**WARRANTY
BULLETIN**

Wb99-06

DATE: March 1999	SECTION : 18 - Body
EXPIRATION: March 2000	
SUBJECT: ADDITION OF A MOULDING TO THE DOOR-LESS PARCEL RACKS

Figure 1: Door-less parcel racks and the new moulding.

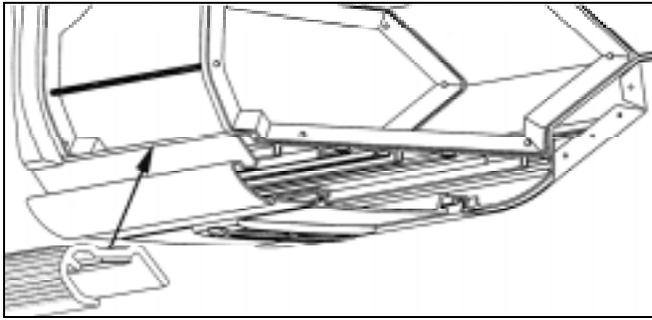
On the above-mentioned vehicles, it is necessary to add a moulding to the **door-less** parcel racks in order to reduce the risks of injuries.

1. Locate the bottom of the door-less parcel racks and the location of the new moulding to be installed (figure 1). Using alcohol, clean the area of each door-less parcel racks where the new moulding will be installed.
2. Remove the tape underneath one moulding.
3. Install the new moulding on the parcel rack, as shown on figure 2, item 2. Make sure that each moulding is located symmetrically between two vertical supports (figure 2, item 1). Press the moulding firmly in place to be sure it is flat.
4. Using the moulding holes as a guide, drill holes into the parcel rack and fix the moulding using the screws included in the kit.

Figure 2: Door-less parcel racks. (1) Vertical supports; (2) New moulding.

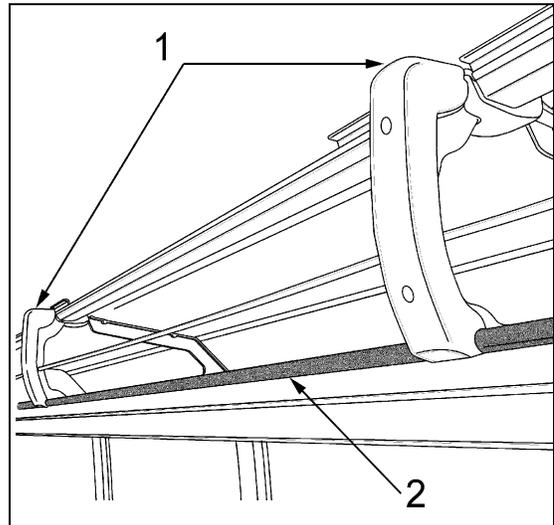
5. Affix and screw the moulding on to every door-less parcel rack.
